STAFF BRIEF

Project: Spirit Plaza

Address: 1 E Jefferson Avenue

SPIRIT PLAZA IMPROVEMENTS

CONCRETE STAINING

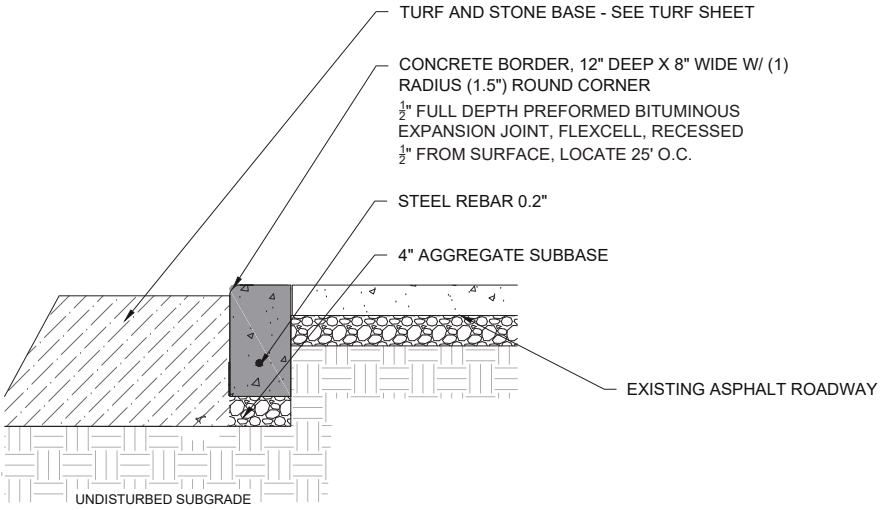
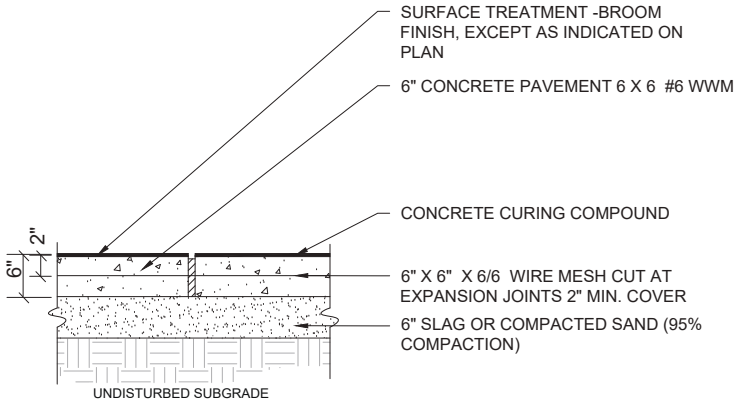
7./9. Explore opportunities to stain the concrete with a lighter shade/brighter color or incorporate ground murals

SHEET TITLE:
CONTAINERS

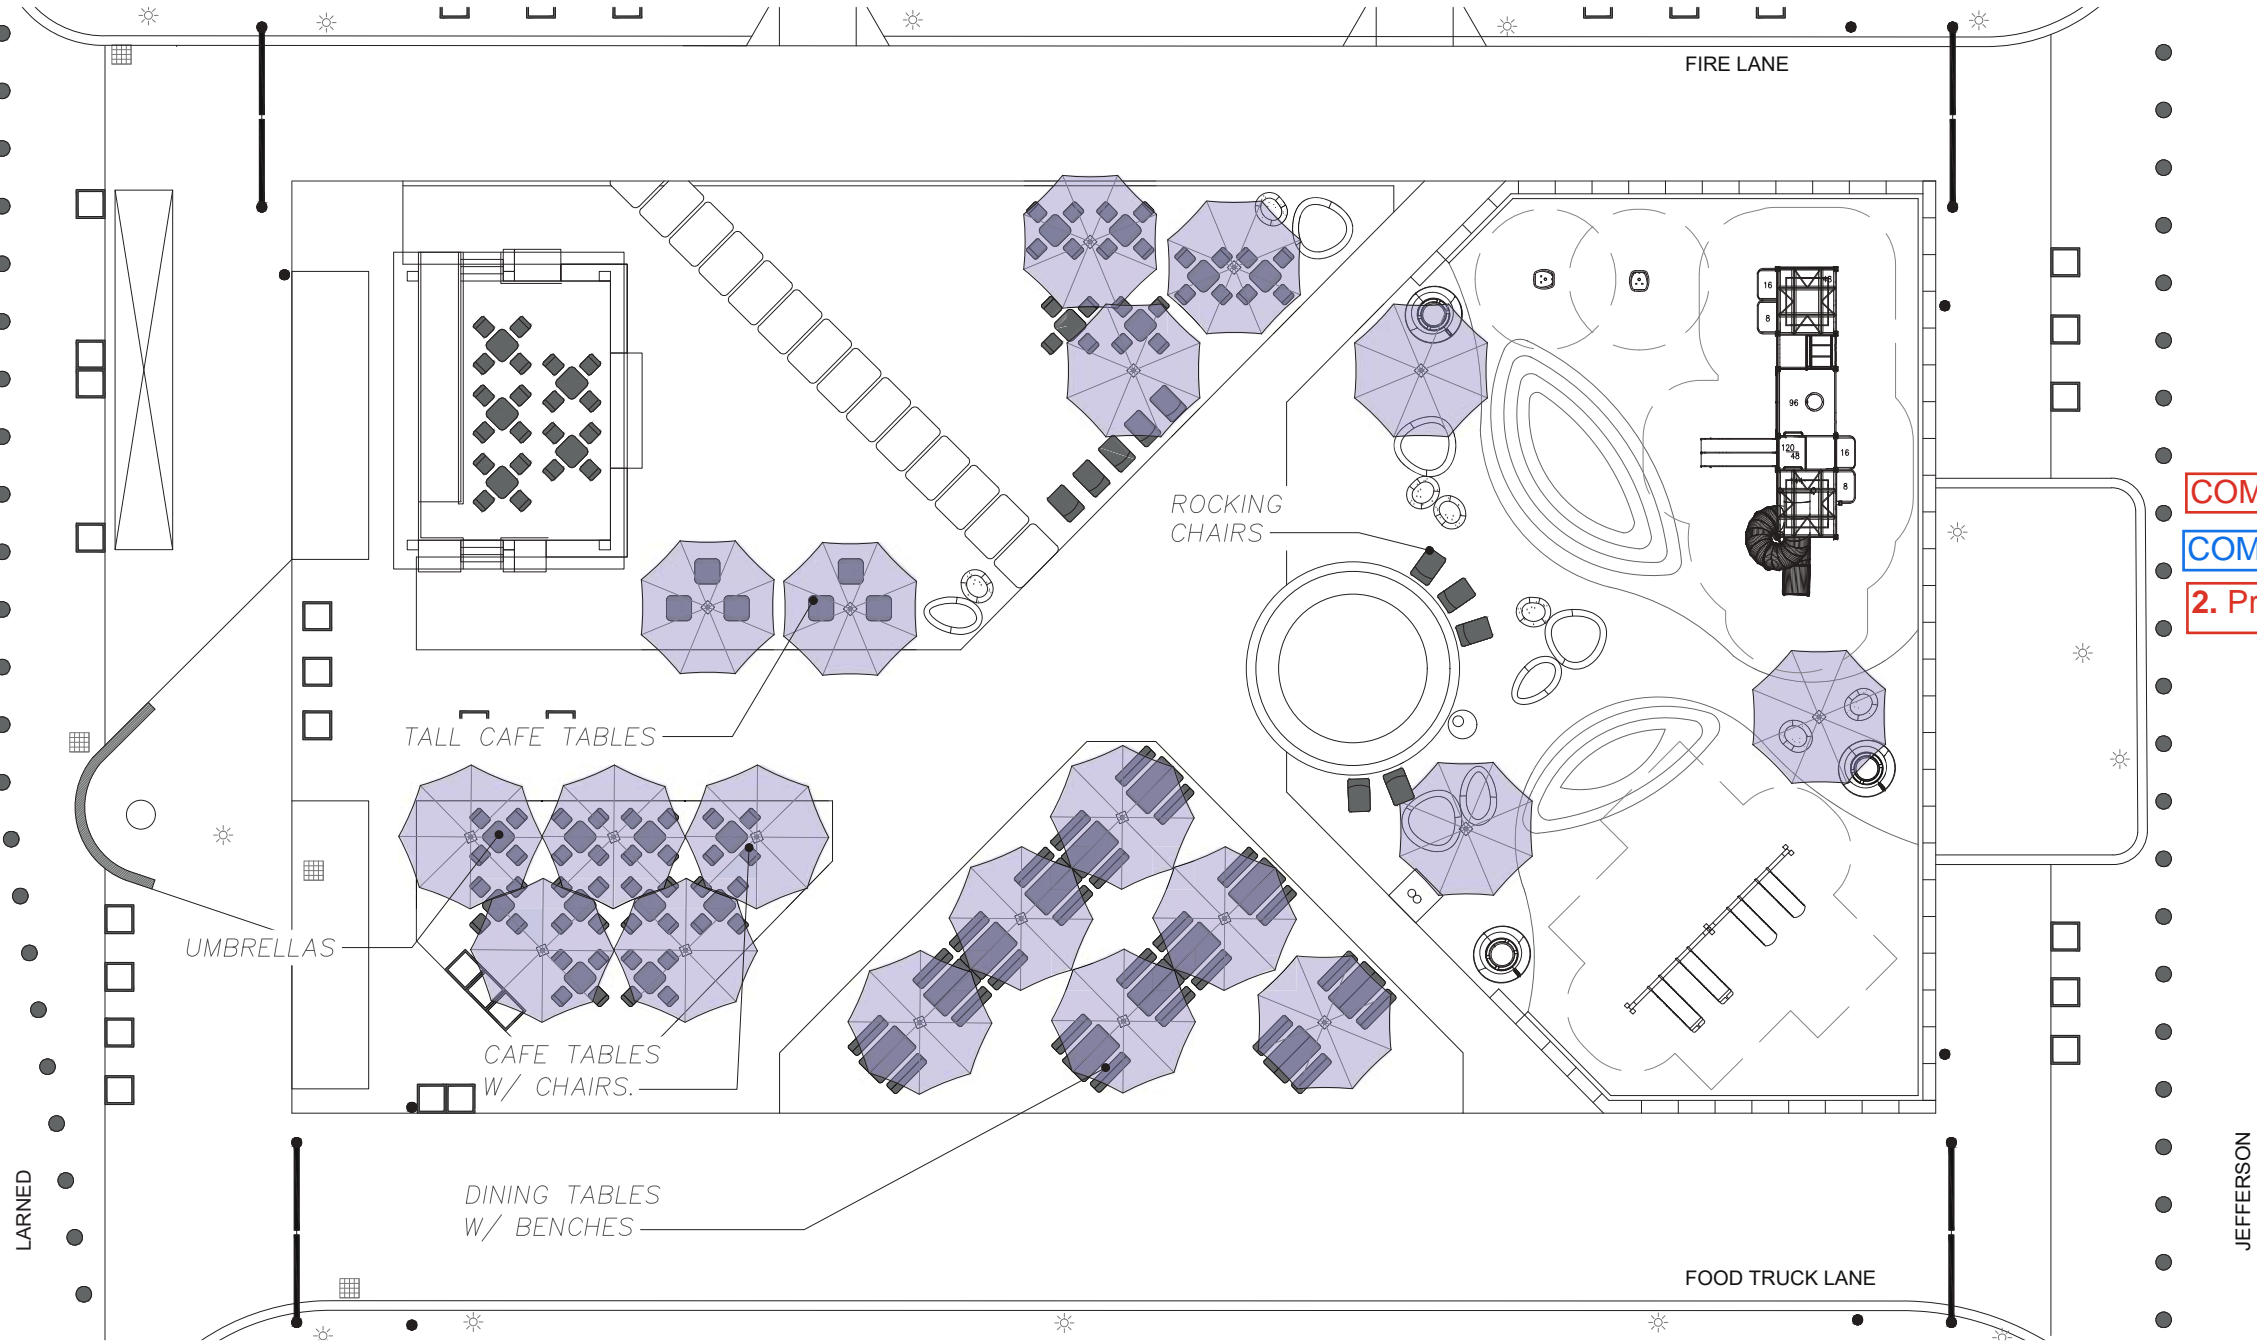
4. Are shipping containers the most effective/appropriate elements for storage in this project? Consider an alternative for storage.

6. When using shipping containers, consider how they are viewed from the right-of-way. Treat containers and consider vegetative screening.

9. Consider adding vegetative screening with arborvitae in planter boxes in addition to the treatments to further conceal the containers from view outside the plaza.

4. Submit drawings illustrating the treatment of these containers. How can their placement serve as a precedent for appropriate use? Consult BSEED regarding requirements for the use of shipping containers. Utilize a combination of cladding & artwork.

AMENITIES

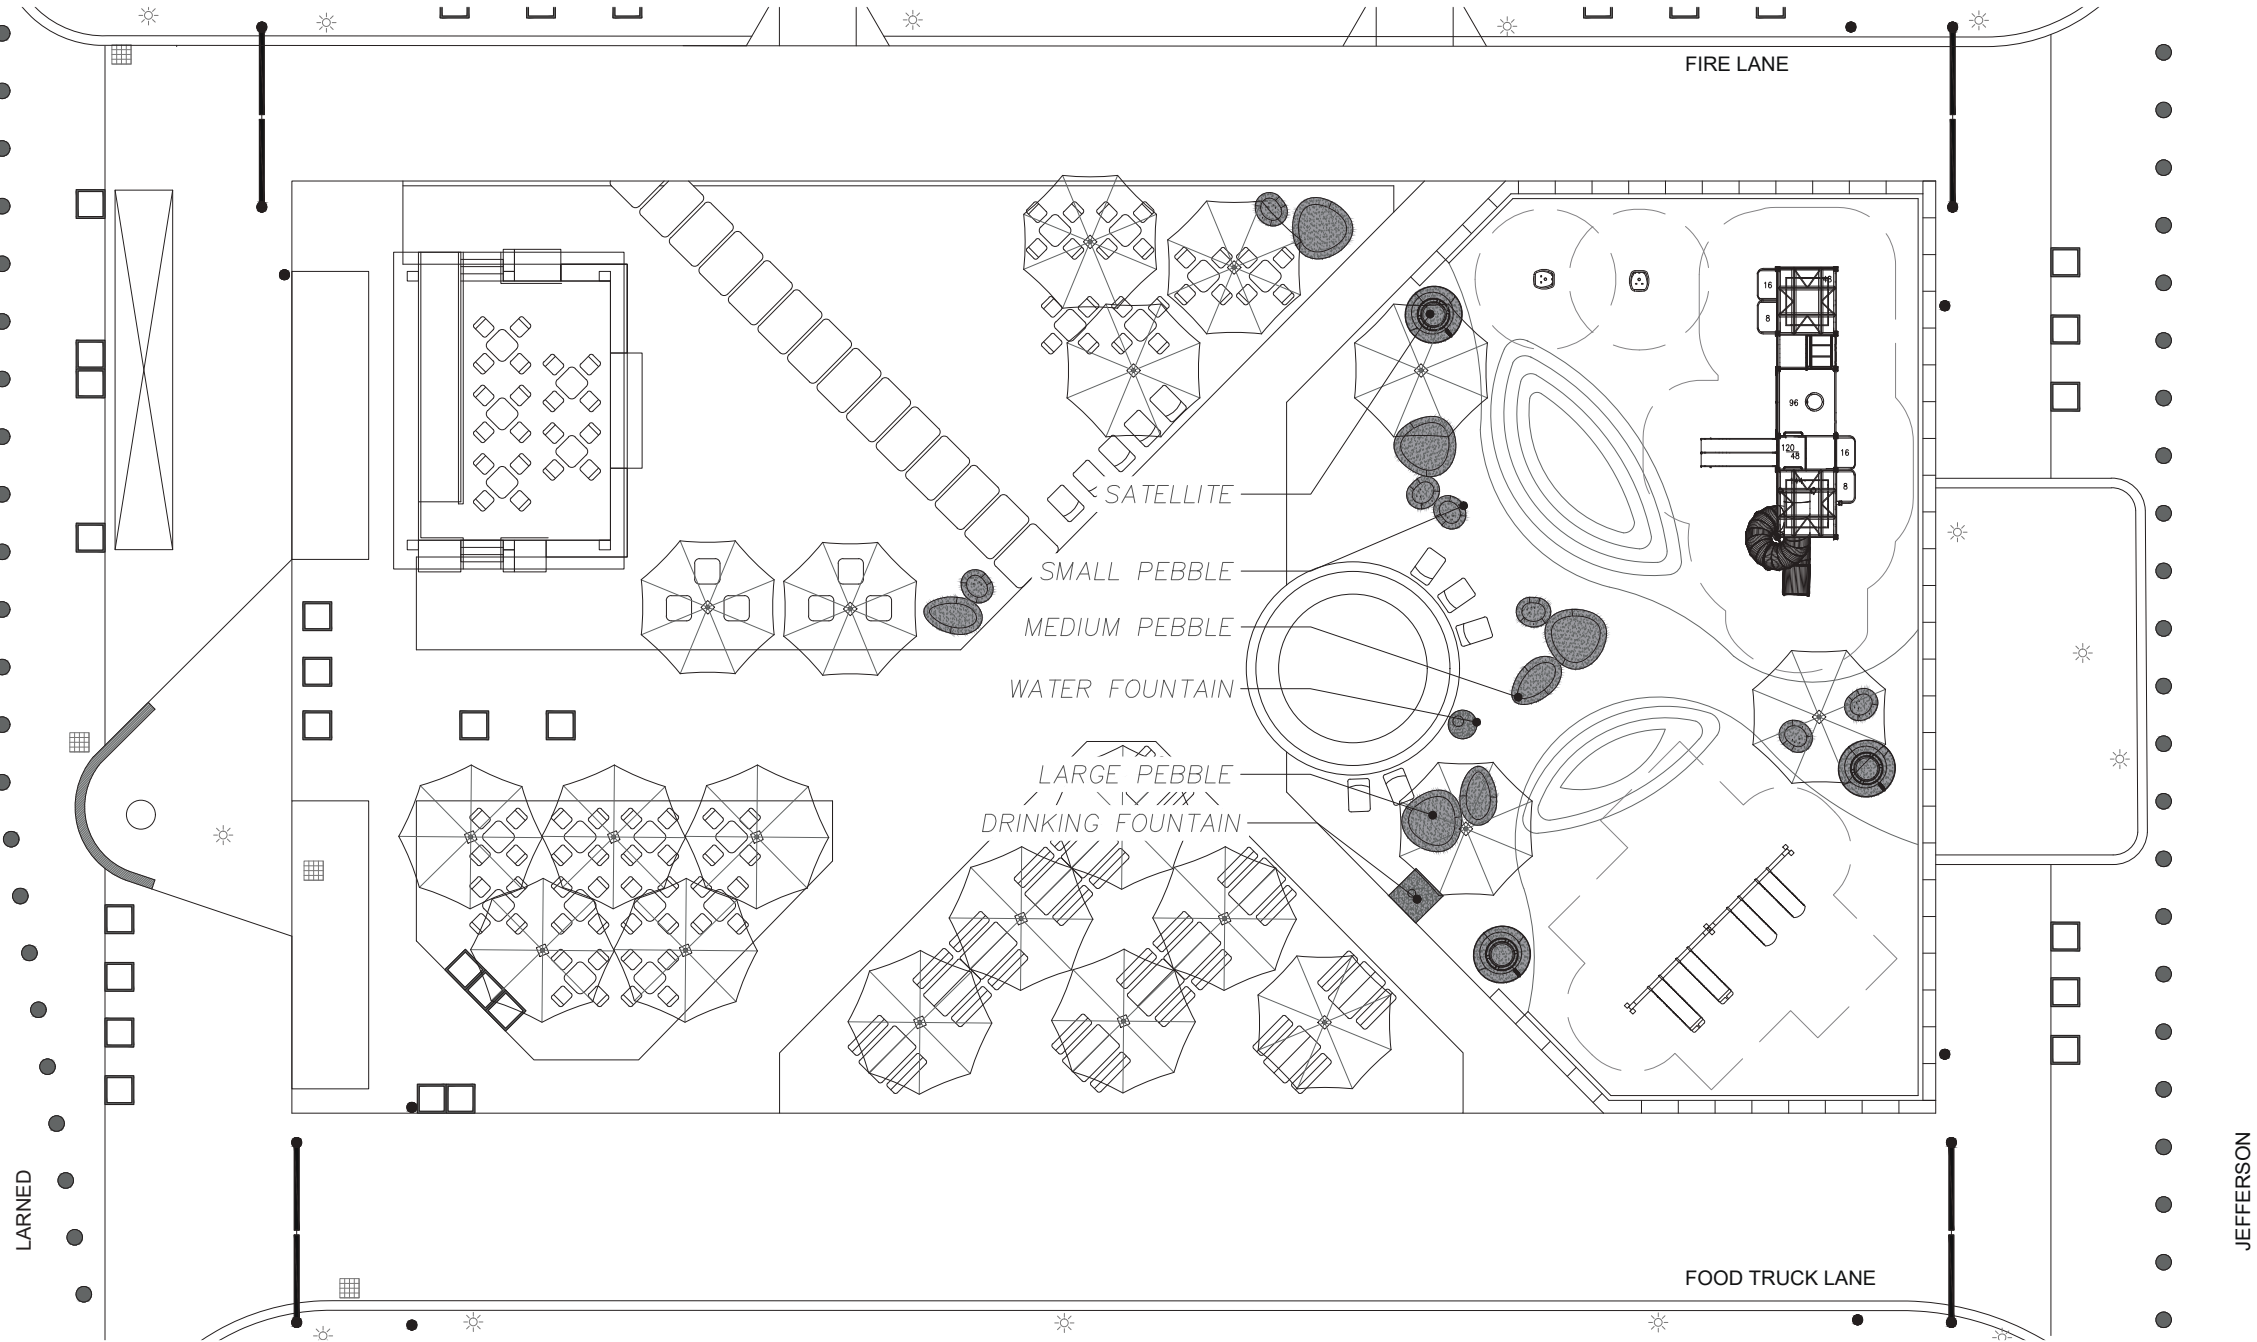
2. Provide compliant trash containers

PLANTER BOXES

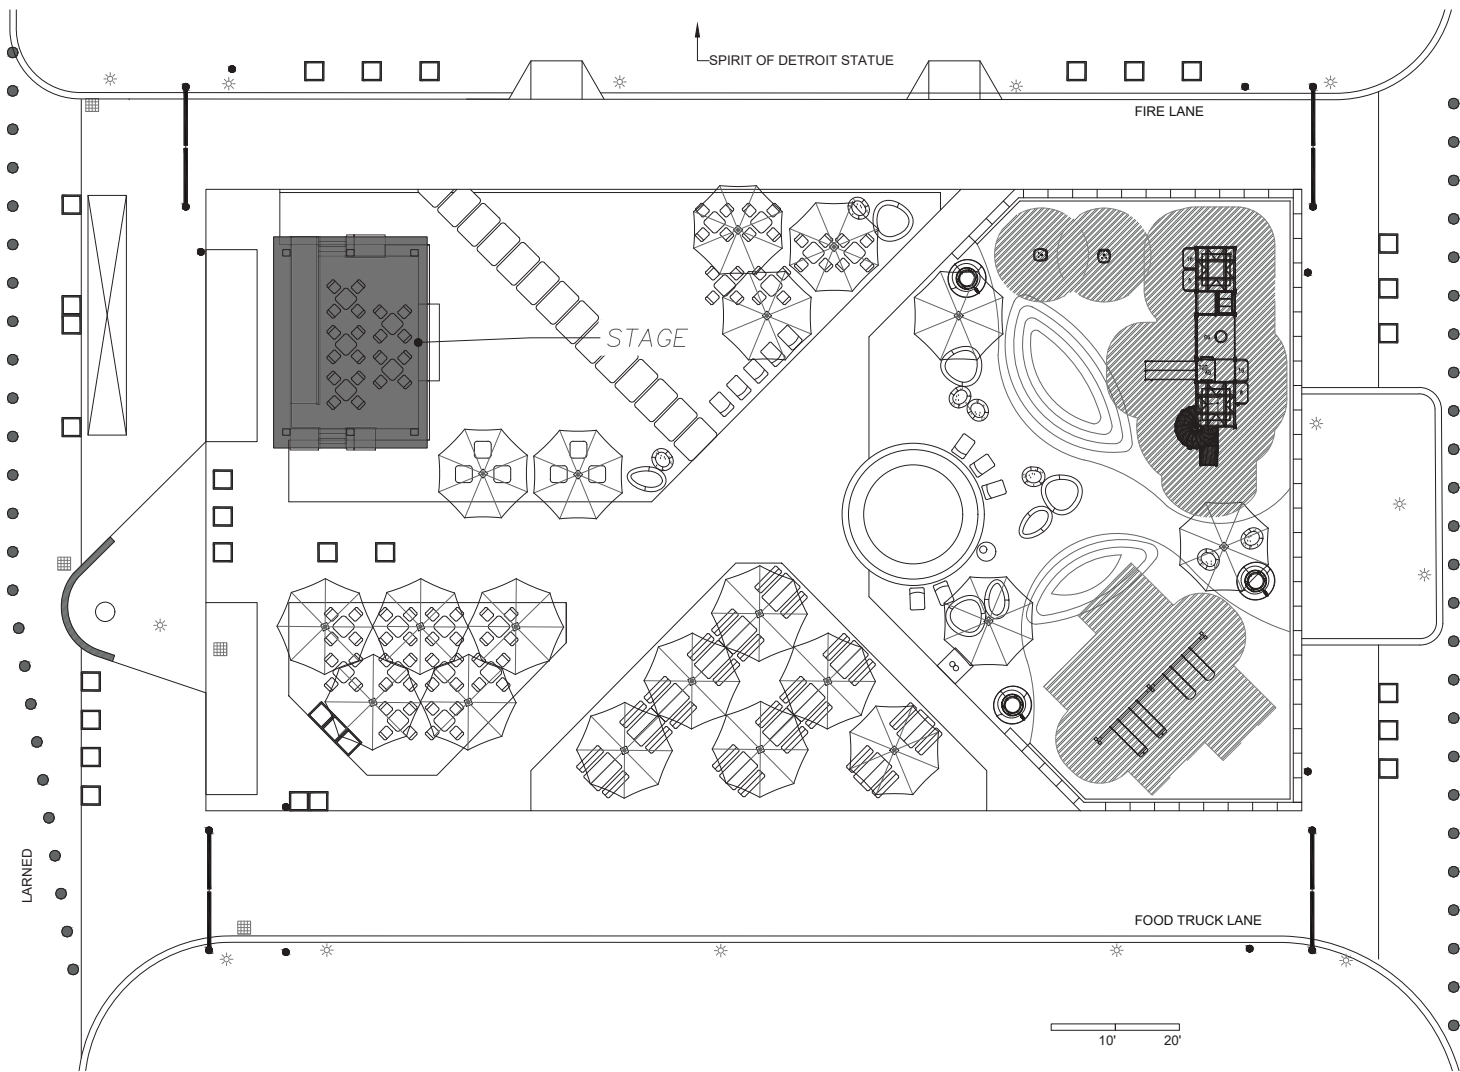
9. In addition to the provided planters, can more natural, native landscape be incorporated?
